STATE OF VERMONT AGENCY OF TRANSPORTATION

PROPOSED IMPROVEMENT BRIDGE PROJECT

MARLBORO
BRF 010-1 (43)

RECORD PLANS	
CONTRACTOR:	RENAUD BROTHERS, INC. - VERNON, VT
RESIDENT ENGINEER:	RON LEMAIRE
CONSTRUCTION BEGAN:	APRIL 8, 2014
CONSTRUCTION COMPLETE:	NOVEMBER 6, 2014
RECORD PLANS BY:	RON LEMAIRE & JENNA HYDE
I HEREBY CERTIFY THAT ALL THE CONSTRUCTION REQUIRED BY THIS SET OF DRAWINGS HAS BEEN ACCOMPLISHED AS INDICATED HEREIN.	
BY	RESIDENT ENGINEER
DATE	02/11/2016
NOTE: Any further information concerning final quantities, amounts or other details relative to this project may be found at Central Files in the electronic archives.

PROJECT NAME: MARLBORO	
PROJECT NUMBER: BRF 010-1(43)	
FILE NAME: s10b414xsl.dgn	PLOT DATE: 28-AUG-2013
PROJECT LEADER: K. HIGGINS	DRAWN BY: K. FRIEDLAND
DESIGNED BY: R. KLINEFELTER	CHECKED BY: G. LAROCHE
MAINLINE SECTIONS 3	SHEET 43 OF 50

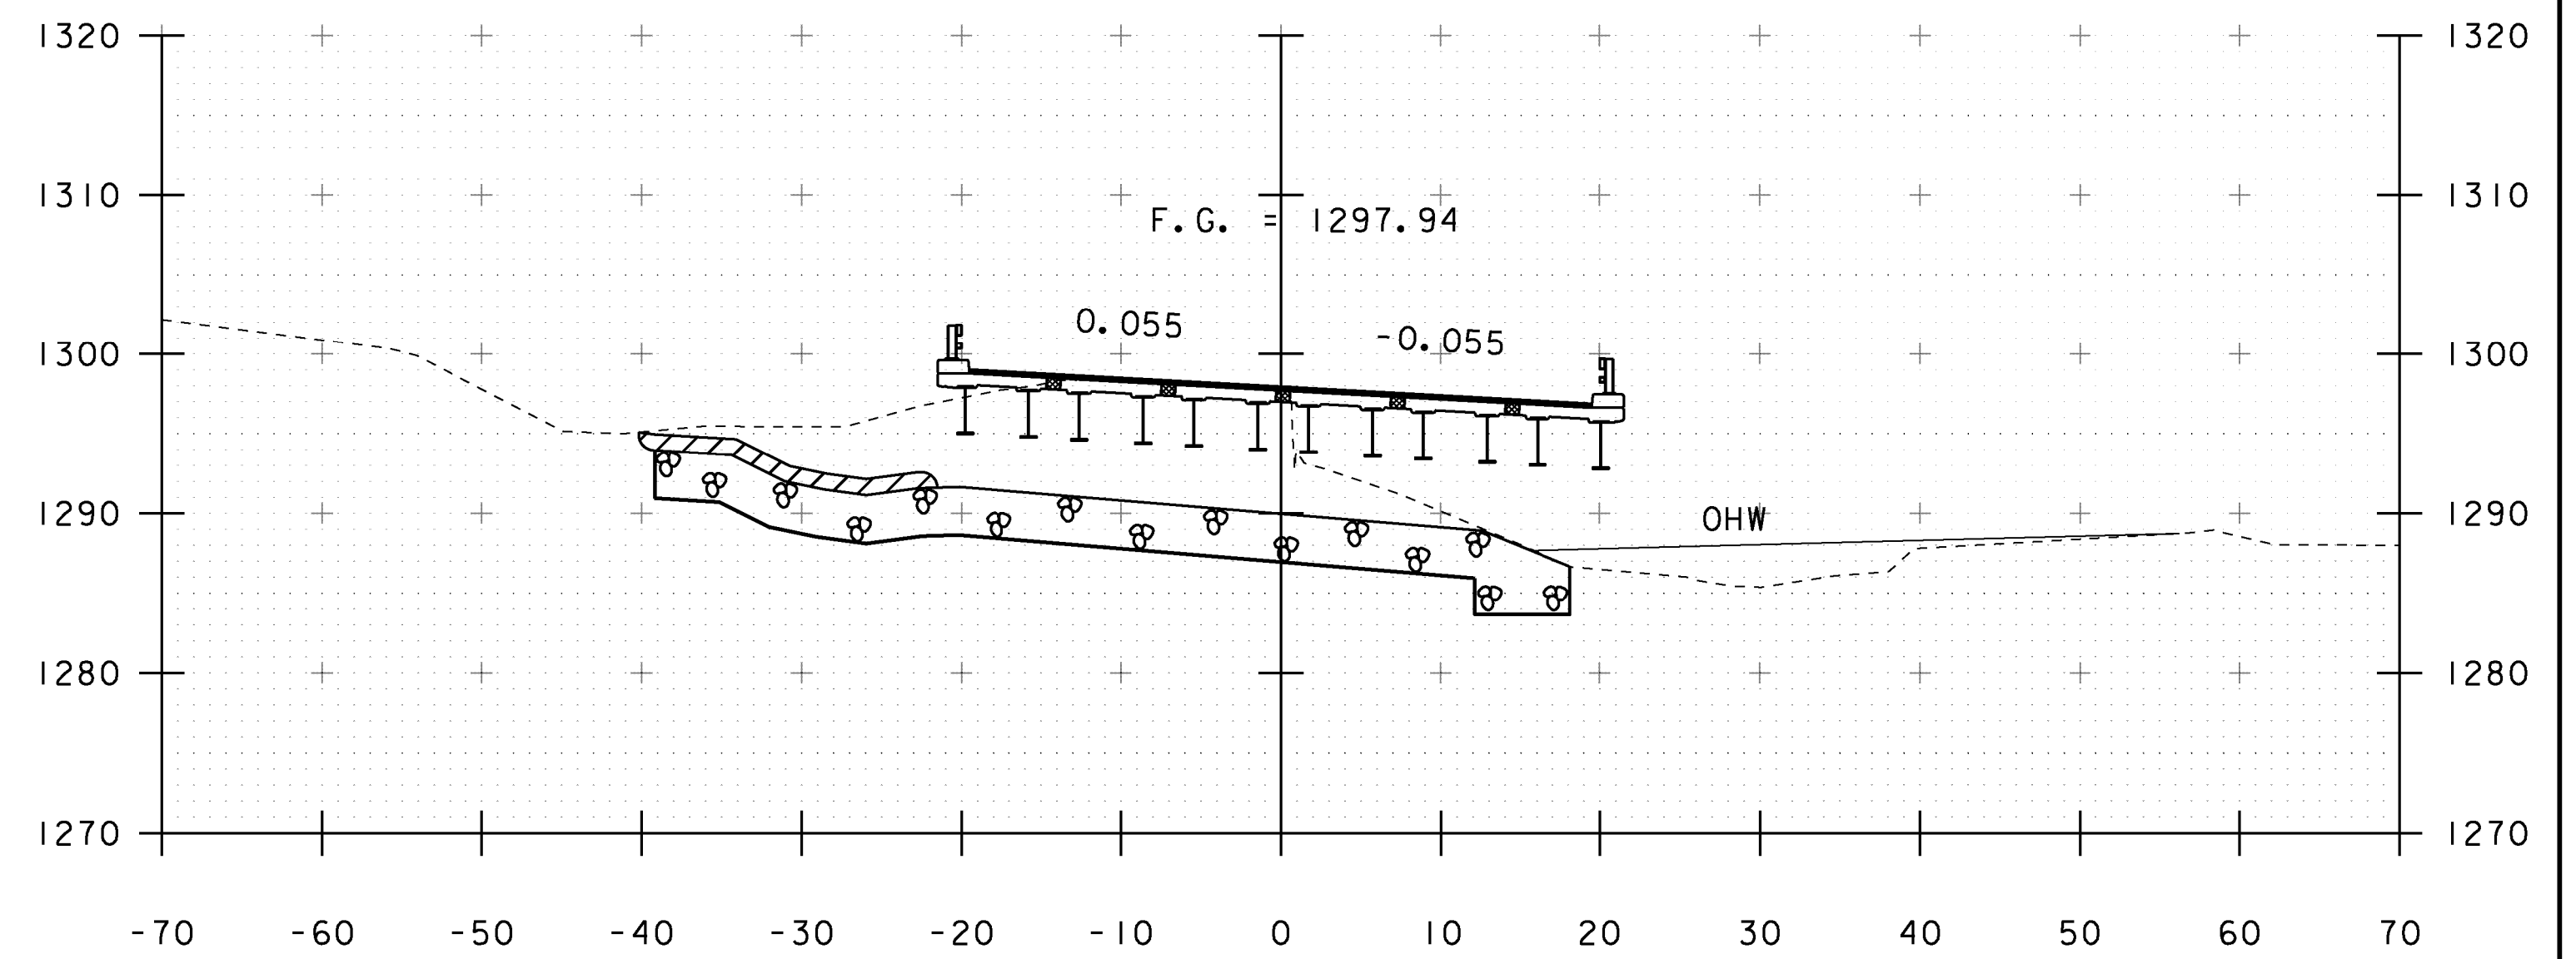
393+50 • REVISED BRIDGE HAS 6 GIRDERS

394+00
 END BRIDGE STA ~~393+93.78~~
 393+93.87

393+25
 BEGIN BRIDGE STA ~~393+12.23~~
 393+12.14
